Concerns Regarding Specific Policy Statements

Figure Concept Concerns

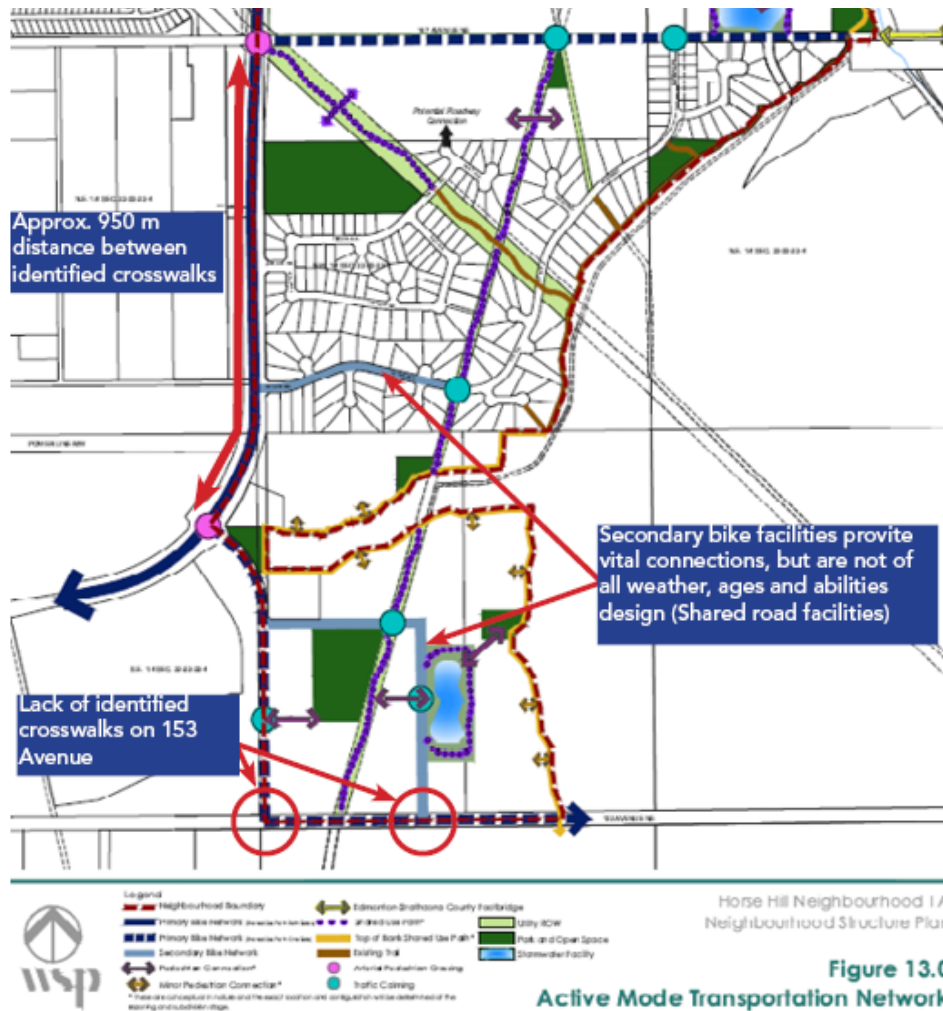
Figure 13.0 Active Mode Transportation Network			
Topic	Concern	Policy Support/Precedents	Proposed Solution
Distance of pedestrian crossings along meridian road (Arterial)	There is almost a 1 KM distance between pedestrian crossings on Meridian road. In addition, there is no mid block crossing along 153 avenue, where the secondary bike facility intersects the road. This will not lead to convenient pedestrian and cyclist movement between neighbourhoods, forcing pedestrians to walk long distances to cross the road	City Plan 4.1.2.1 Prioritize safe streets and convenient pedestrian crossings that appropriately serve the context of the area.	That the active mode network be amended to include at least 1 additional pedestrian crossing along meridian road and an additional crossing along 153 avenue.
Secondary Bike Network Facilities	These facilities provide a vital connection point for active users, but as proposed, would be shared road facilities. Shared road bike facilities do not accommodate all users of all ages, abilities and comfort levels, and are not in consideration of all season design	1.3.2.2 Increase opportunities for Edmontonians to be physically active throughout all seasons. 2.1.2.2 Provide safe, comfortable and direct active transportation connections between neighbourhoods, community facilities and schools. 4.2.3.2 Provide opportunities for universal accessibility within the active transportation network.	That the secondary bike network facilities identified in the NSP be amended to be primary bike network facilities, to support the intent behind a multi-modal community

FIGURE - Specific concerns regarding the active transportation network in this NSP.
